**AERONAUTICAL CHARTING MEETING  
Instrument Procedures Group  
Meeting – October 25 - 26, 2021**

**RECOMMENDATION DOCUMENT**

**FAA Control # 21-02-360**

**Subject: Insufficient Guidance on How to Process Minima-Related Notes on IAPs**

Figure 1. Example of long note (KINL RNAV 31).

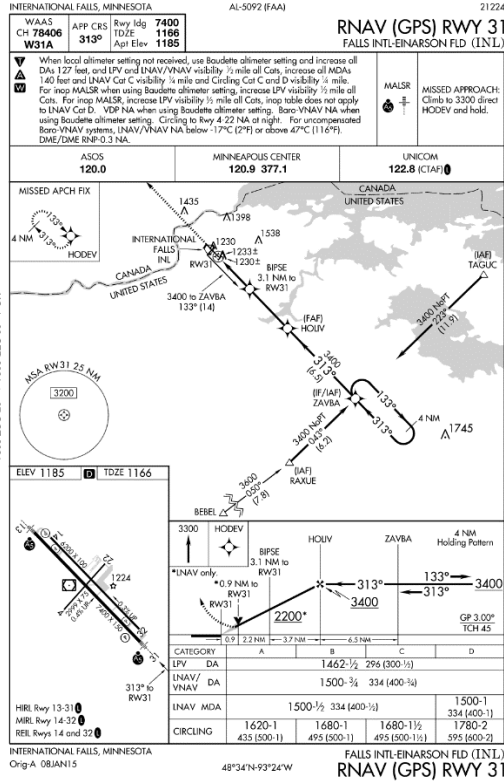
Some instrument procedures have multiple notes related to minima, as shown in Figure 1. The notes have three sections:

1. When local altimeter not received;
2. When inop MALSR and remote altimeter; and
3. Inop MALSR.

Condition 1 specifies an altitude and visibility adjustment; Condition 2 adds another visibility increase; and Condition 3 yet another visibility increase (albeit, some pilots would likely not apply condition 3 as conditions 1 & 2 address the situation). While the TERPS “Inoperative Components for Visual Aids Table” specifies “If more than one component is inoperative, each minimum is raised to the highest minimum required by any single component that is inoperative,” there is no such guidance for non-standard adjustments.
